Re: Palmeraie Phase II -City of Scottsdale Comment Response Letter  
Re: 7-ZN-2016#2  
Key Code: 95T74  
CVL Project No.: 1.01.0268924

The following is a summary and response to the comments provided as a part of the 1<sup>st</sup> review for the above referenced project:

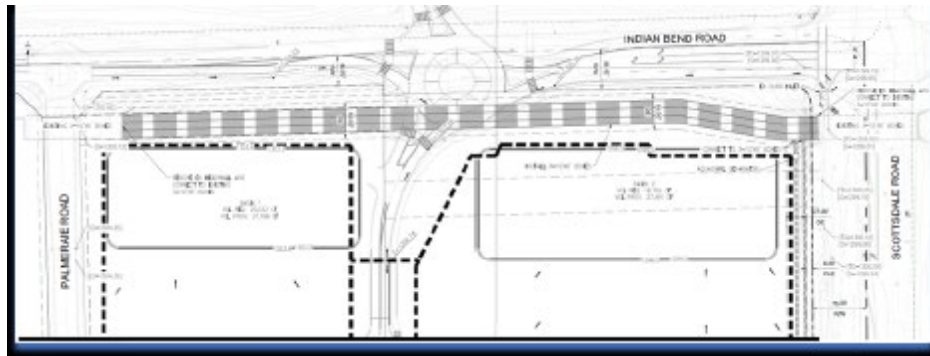
- h. The Engineer must show/call out the locations, size, and invert elevations of all storm drain pipes and box culverts in sections A-A & B-B as appropriate. The Engineer must also show the limits of the proposed D.E. in sections A-A & B-B as appropriate. The rule of establishing the limits of the proposed D.E. over a storm drain pipe or over a box culvert was explained to the Engineer in a meeting and this rule must be verified and followed when dedicating the proposed D.E. over a storm drain pipe or over a box culvert. It should be noted that more cross-sections maybe requested by the reviewer during the Improvement Plans review. (DSPM, Sec. 4-1A)

***Response: SD profiles have been included in this submittal as a part of the preliminary drainage report. Limits of required drainage easements have been provided on preliminary grading plans.***
